Notice of the changing specification articles

① High pressure rubber hose Type :**H3/8**

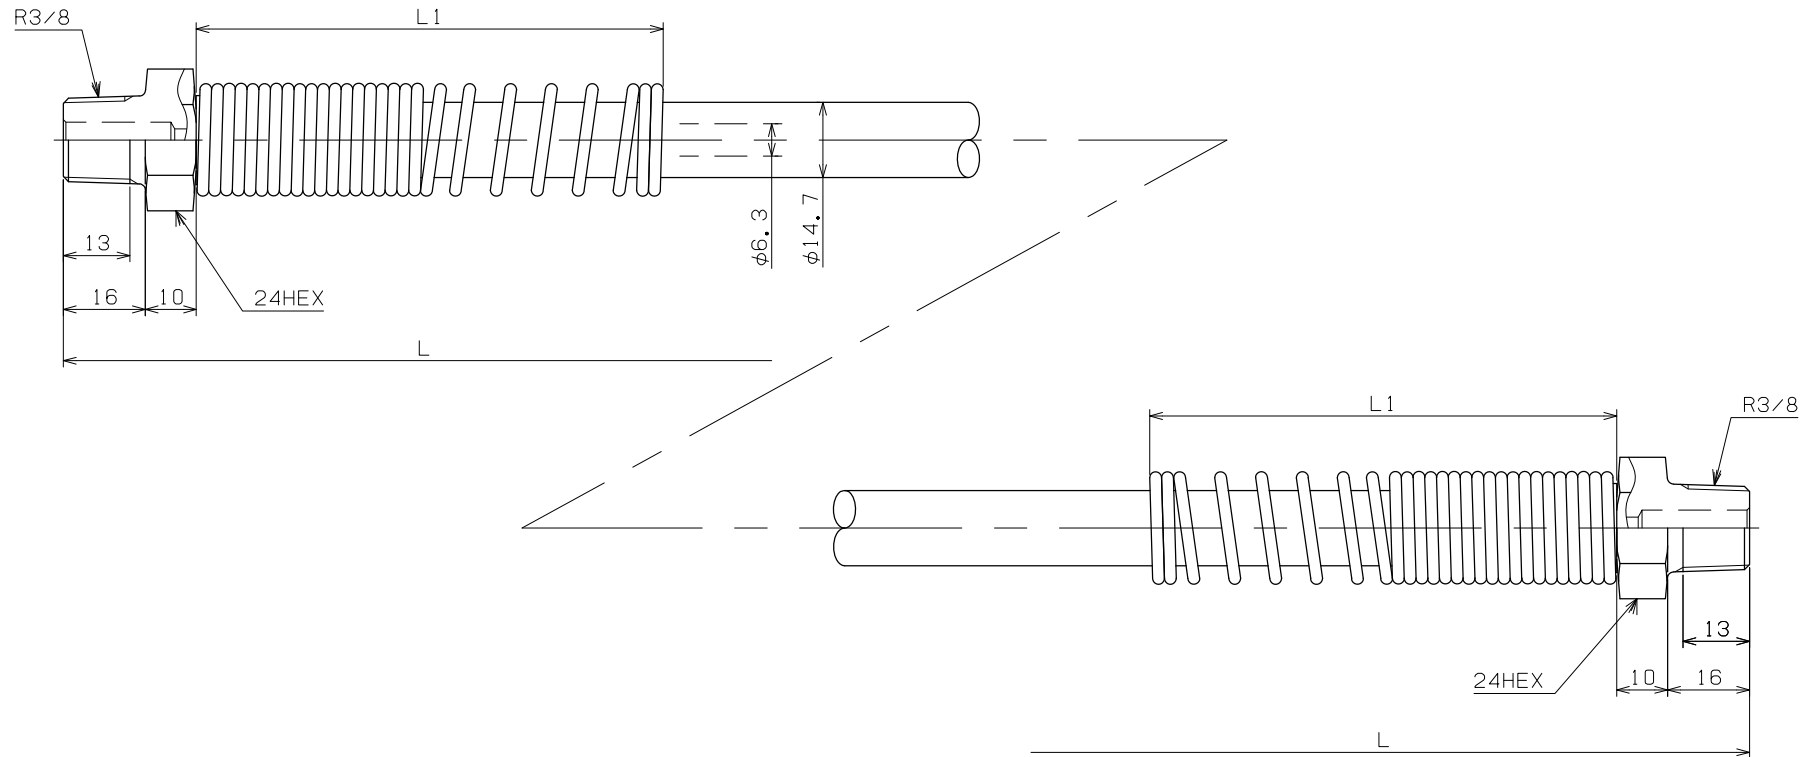
The specification will be changed when all the stock has been sold out for each length.

● It is compatible with old version. Refer to the following pages.

●	Maximum operating pressure	MPa	70
●	Minimum curve radius	mm	100 <i>※It was 120</i>
	Capacity	cc/m	31.2
	Hydraulic oil used		General hydraulic oil
	Approximate weight	kg/m	0.38 <i>※It was 0.5</i>
